pd-trigger — Design Document

ai-ee v1 pipeline

Board review (P8 adversarial) - pd-trigger

Schematic review waivers (pd-trigger)

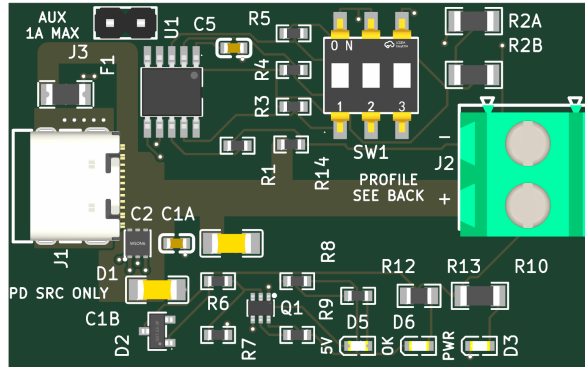
W1 dp-dm-short-at-chip: architecture's PD-only short (/BC12.DIS) ACCEPTED by the reviewer as hardware-SAFER than the datasheet's connector wiring (removes a 21V-onto-3.8V-abs-max fault path). Cost: no QC/BC legacy support - the board is "PD sources only"; goes on B.SilkS + order docs. W2 vdd-worst-corner: true worst case 0.979mA at 4.4V low-line all-straps- closed vs unpublished CH224K IDD - bounded by WCH's own reference circuit; V1 bring-up step: measure VDD at the 5V profile; contingency = both 510R -> smaller (documented floor 600R total). Bring-up addenda: buzz out Q1 E/B/C once (clone PDF JS-gated; Nexperia- standard pinning verified as the compatibility claim).

reports/render_final/top.png

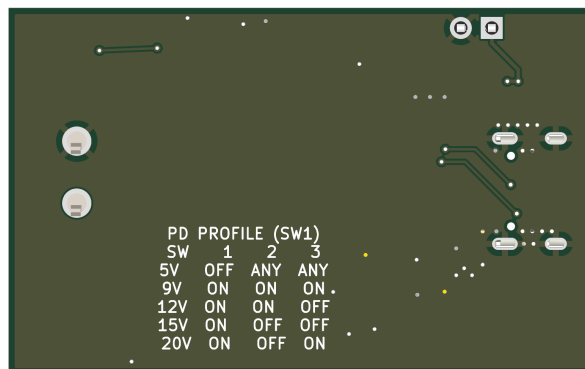
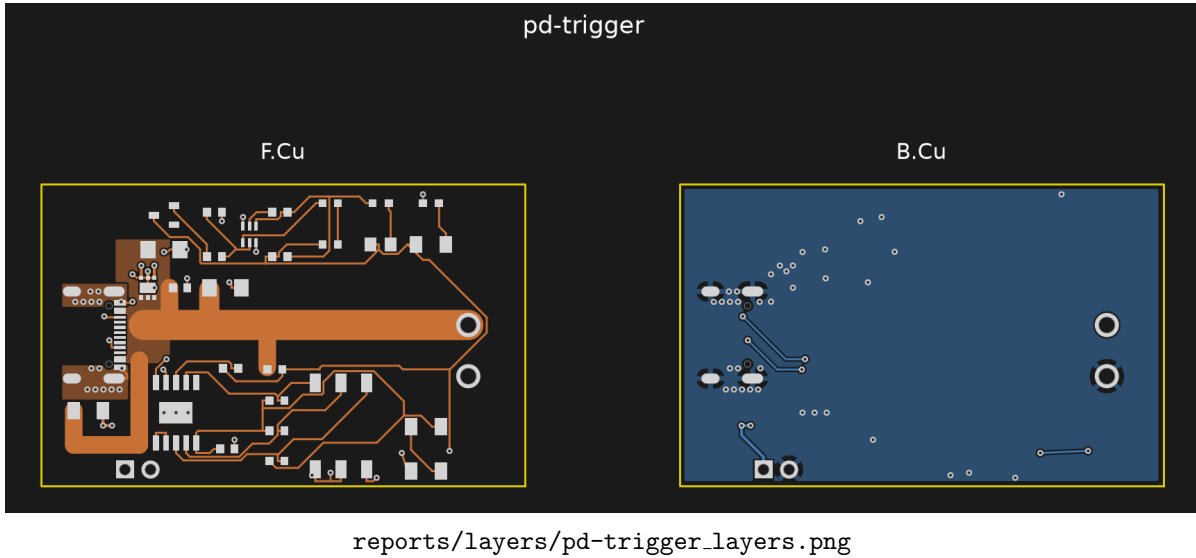
E1 - 5 A return chokes at J1's GND contact pads (error, checker-blind by design D7)

The 4 GND cable contacts land on two merged SMD pads (F.Cu only): A1-B12 at (17.63,39.31) and B1-A12 at (17.63,45.71), nominally 2.5 A each at the 5 A rating. Their ONLY copper into the B.Cu return pour:

- A1-B12 (top): a 0.2 mm wide, 2.7 mm long F.Cu chain (3 segments) into shell pad 1's THT barrel, plus one 0.6/0.3 via whose annulus grazes the pad corner by ~0.05 mm (etch-tolerance-level). 0.2 mm at 2 oz = 0.80 A capacity at 10 C rise (pipeline model); at 2.5 A the same model gives ~133 C rise (short-neck heatsinking will moderate this, but it is a >3x overcurrent on the model's own terms). ~13.6 squares = 3.3 mohm.
- B1-A12 (bottom): a 0.2 mm x 1.3 mm trace into ONE 0.6/0.3 via. The board's own via budget (constraints via_amps 0.5) says 2.5 A needs 5 vias; there is 1. Shell pad 4 sits 0.32 mm away but is NOT connected on F.Cu - its copper does not help.

Architecture D7/power_tree structural requirement ">= 10 vias at J1's GND pads" (the stated substitute for keeping GND out of power[] so check_current stays quiet): not delivered. DRC cannot see it (0.2 mm is netclass-legal), check_current cannot see it (GND undeclared), check_return_path no-ops (no high_speed key). Failure mode: sustained 5 A at any profile heats the two necks far past the 10 C design intent; long-term trace/joint fatigue, intermittent ground, and full return current cascading onto the surviving 0.2 mm chain. Fix is cheap at P9: an F.Cu GND spandrel bonding each contact pad to its shell pad (the VBUS pour top edge is at y 39.7 - the strip above it, and the strip x < 17.2 plus the region south of y 46, are free) plus 4-5 vias per side.

E2 - Safety/waiver silk markings absent (error, promised artifact) Board-wide gr.text count is ZERO; B.SilkS carries nothing at all (both B.SilkS references in the file are the stackup layer table). Missing, each one a written promise:

- AUX 1A MAX + V+/GND at J3 (P0 answer 4 "silk-marked", V10). F1 makes overload safe-by-hardware, but polarity of the 2-pin aux header is unmarked.
- PD SOURCES ONLY (ERC waiver W1's standing condition: "goes on B.SilkS + order docs"). The waiver's silk half is currently unfulfilled.
- J2 screw-terminal polarity. Trunk lands on J2 pad 1 = the LOWER screw (board-bottom side); nothing anywhere tells the bench user which screw is V+. Reverse-wiring a load on a 100 W output is the single easiest field mistake this board can cause.

E3 - User-interface silk absent (error, promised artifact)

- The five-row profile table on B.SilkS - D3 calls silk "the user interface" and specifies the table verbatim; the bottom is a clean pour with room. Without it the ON/OFF-to-voltage map exists only off-board; a user WILL set 9 V expecting 12 V by trial and error. (Fail-safe floor: any wrong guess >= the 5 V fallback, and OFF-fail = 5 V - the mistake is bounded but real.)

- LED legends PWR / 5V ONLY / PROFILE OK (D4/V10): the render shows refdes D3/D5/D6 only. The entire P0-answer-6 "visible fallback indication" scheme is mute without the words - a lit red LED labeled "D5" indicates nothing.

W1 - J1 mouth recessed ~0.4-0.5 mm behind the board edge (warning, flagged at P6) Courtyard/silk front edge $x = 10.18$ vs board edge $x = 9.8$. USB-C receptacles are normally flush-to-overhanging; a recessed mouth lets thick/molded plug overmolds butt the board edge and hold the plug fractionally short of latch - intermittent CC, no PD, "works with some cables". On a bare bench board with arbitrary cables this is a real annoyance risk. Fix: nudge J1 -x 0.5-1.0 mm at P9 (pour edge follows; nothing else in that corridor), or accept and note in order docs.

W2 - Outline 48 x 30 mm exceeds the architecture's hard ceiling (warning, drift) Edge.Cuts = (9.8,27.51)-(57.8,57.51) = 48 x 30 mm. D9: nominal 45 x 25, "hard ceiling 48 x 28 mm"; 30 mm violates D9's own ceiling by 2 mm even though it equals P0 answer 5's literal +20 % (40x25 -> 48x30, +44 % area vs the brief's target). No digest discloses the growth past D9. Consequence is cost/footprint only, but it must be disclosed to the user at the checkpoint rather than discovered.

A1 - J2 GND pad ties to the return pour through 4 thermal spokes (advisory) J2 pad 2 (THT, 2.4 mm pad / 1.6 mm drill) connects via 4 x 0.5 mm diagonal spokes = 2.0 mm total at 2 oz -> model 8 C rise at 5 A. Legal and functional, but these are the most-loaded copper necks on the whole return after E1, at a hand-soldered joint. Recommend a solid-connect override (or a short fat GND strap) at P9; zero cost. (Verified all 4 spokes present; the VBUS pad 1 island below it is barrel-tied, normal.)

A2 - F1's VBUS feed branch is 18.3 mm long (advisory, V8 letter-violation) V8/D8 wanted all five VBUS taps hugging the run with 2-3 mm stubs. D1, C1A, C1B, C2, R14 comply; F1's feed runs 8.4 + 6.5 + 3.4 mm at 1.75 mm width to the top-left corner. Width-compliant (V8's actual purpose), carries ≤ 1 A in service; only cost is ~30 mm² of extra always-live 20 V copper. No action needed; recorded as drift.

A3 - Floating 0.65 mm² GND sliver at (20.0, 28.5) (advisory, cleanup) plane_repair's own dead-island fact (0 anchors), between J3/SW1 clearances. Cosmetic / minor DFM nit; remove at P9 cleanup or accept.

A4 - /VAUX at PPTC max-non-trip current (advisory) /VAUX routes at 0.3 mm (required 0.25 at the declared 1.0 A -> 7 C). F1's worst sustained NON-trip current is ~1.8 A -> model 27 C rise on those runs until/unless the PPTC trips. Bounded, no damage threshold approached (70-80 C copper on a 20 V node); acceptable. Recorded so nobody "fixes" it blind later.

```
# P8 digest (pd-trigger)
verify PASS 8/8 first try. Fable reviewer: 4 err + 2 warn. Copper errors
REAL: 5A RETURN choked at J1 GND pads (0.2mm necks/0.80A, 1 via) - rebuilt
w/ priority-1 F.Cu GND lobes (connect.pads solid) + 15 new 0.6/0.3 vias ->
5.68A/4.70A per pad, 16 vias (D7 >=10 met). Removed 2 stitch vias 0.121mm
from THT drills - LIVE-PROVEN KiCad DRC blind spot (via-drill vs same-net
pad-drill never checked, finding 34). Silk errors: 17 texts added; agent
CORRECTED the orchestrator's B-table spec (raw CFG bits would be inverted
vs ON=GND switch reality - printed switch positions). Warns: mouth recess
-> order docs; outline 48x30 deviation recorded; C1B channels waived w/
numbers. Re-gates: drc_routed 0/0, verify 8/8. H4 AUTO-approved.
```
